## **Process Change Notification**

**Date:** October 8, 2013  
**PCN Reference:** S20304 Rev 3  
**PCR Reference:** PCR # AP-1242-EN-0641  
**Product Reference:** Power Management Devices– SOT-223 FET

Wire bond material change from Gold to Copper, for the assembly of SOT-223 FET products.

Materials:

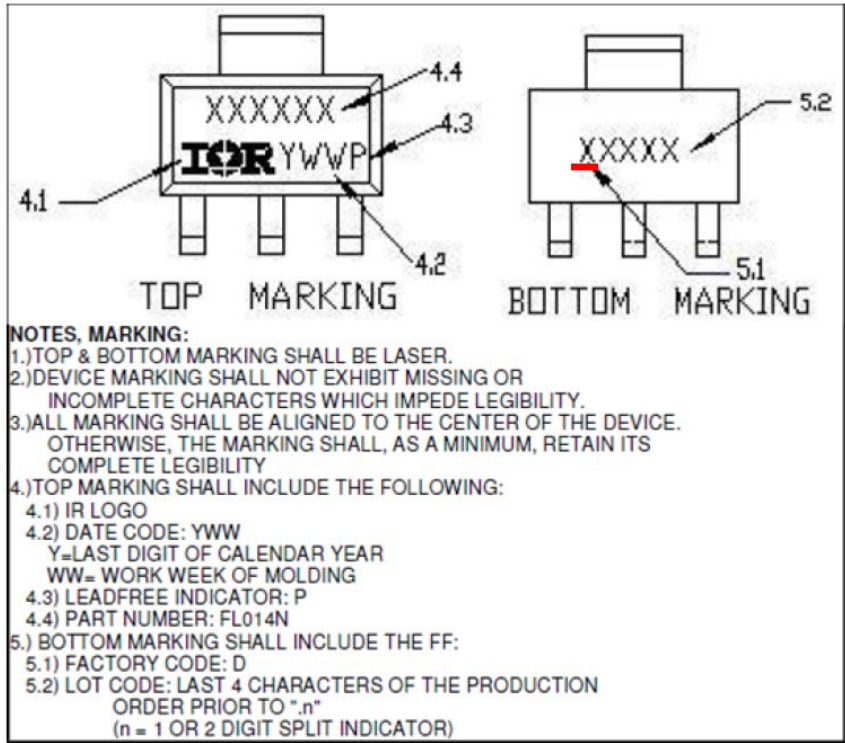
Current SOT-223 parts use Gold wire to provide the electrical connection between the package leads and die. The wire material will change from Gold to Copper, but the number of wires will remain the same.

From: Au wire  
To: Cu wire

From: Sumitomo compound  
To: Halogen-free Sumitomo mold compound
